**Subject: Vermont Yankee Nuclear Power Station  
License No. DPR-28 (Docket No. 50-271)  
Vermont Yankee Emergency Plan Implementing Procedure Changes**

To: E-Plan Implementing Procedure Controlled Set Holders  
From: Technical Support - DCC - Ann M. Pichette - MC 1220  
Date: January 21, 2004  
Re: Entergy Vermont Yankee Emergency Plan Implementing Procedure Change #224,  
Instruction Sheet

A. Procedure No.: <b>OP 3547</b>		Current Revision #: <b>2</b>	Title: <b>Security Actions During An Emergency</b>
B. Description of Change: <b>Added reference to Security Post Order 02-06.</b> <b>Added step to ensure Security Post Order 02-06 is being performed.</b> <b>Added Figure 1 – Alternate Evacuation Route &amp; Evacuation Announcement Locations</b>

FIGURE 1

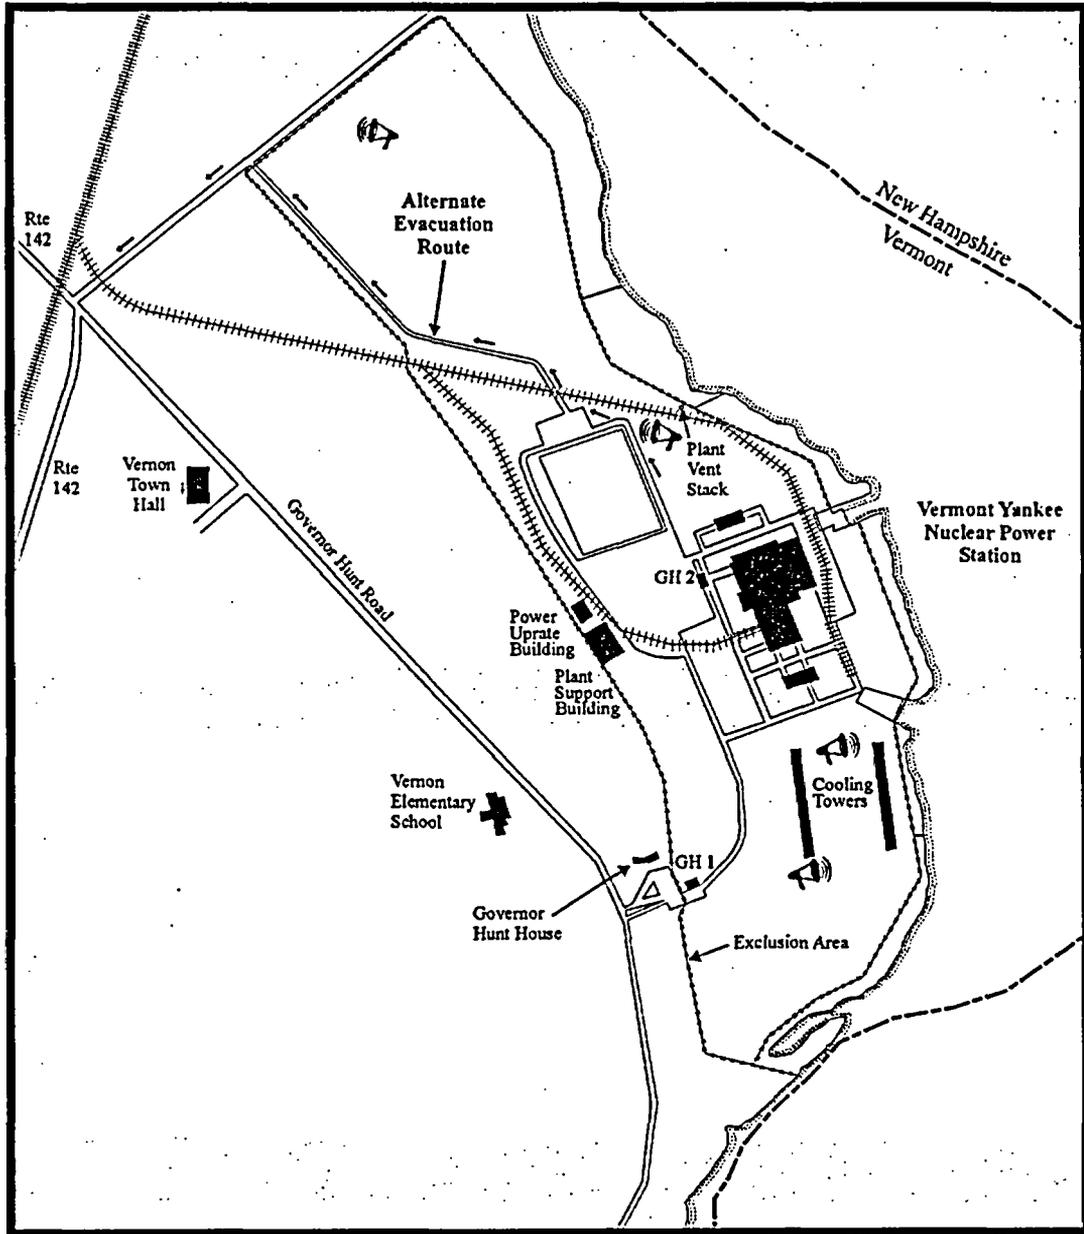
H. Page(s) affected: <u>Pages 4,5, and 7 of 8, Figure 1 page 1 of 1</u>

Figure 1, OP 3547 Alternate Evacuation Route & Evacuation Announcement Locations, depicts the general locations for Security patrols to make announcements and also identifies the alternate evacuation route.
